Changes and Additions to 1450.1 document (6/21/01)

1. Issues list

This is a list of issues or questions that I have with regard to the current state of dot-1 (tony).

4. Signal Mapping Using SignalVariable and Expressions (sigvar_expr)

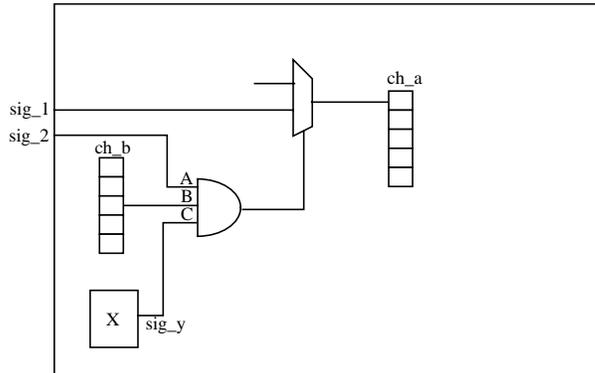
MacroDefs {
    mac_a {
        C { sig_a[1..5] = #; sig_b[1..5] = #; grp_c = #; sig_d = #; }
        V { sig_aa[1..5] = 'sig_a[1..5]'; }
        V { sig_bb[1..5] = 'sig_b[5 3 1 2 4]'; }
//      V { sig_bb[3 4 2 5 1] = 'sig_b[1..5]'; } // alternate stmt
        Shift {
            C { grp_c[5 4 3 2 1] = 'grp_c'; } <=== need to be outside shift?
            V { sig_cd = 'sig_d[1..5]' 'grp_c[1..5]' ; }
//          V { sig_cd = 'sig_d[1..5]' 00000 ; } // alternate stmt
//          V { sig_cd = 00000 'grp_c[1..5]' ; } // alternate stmt
        }
    }
}
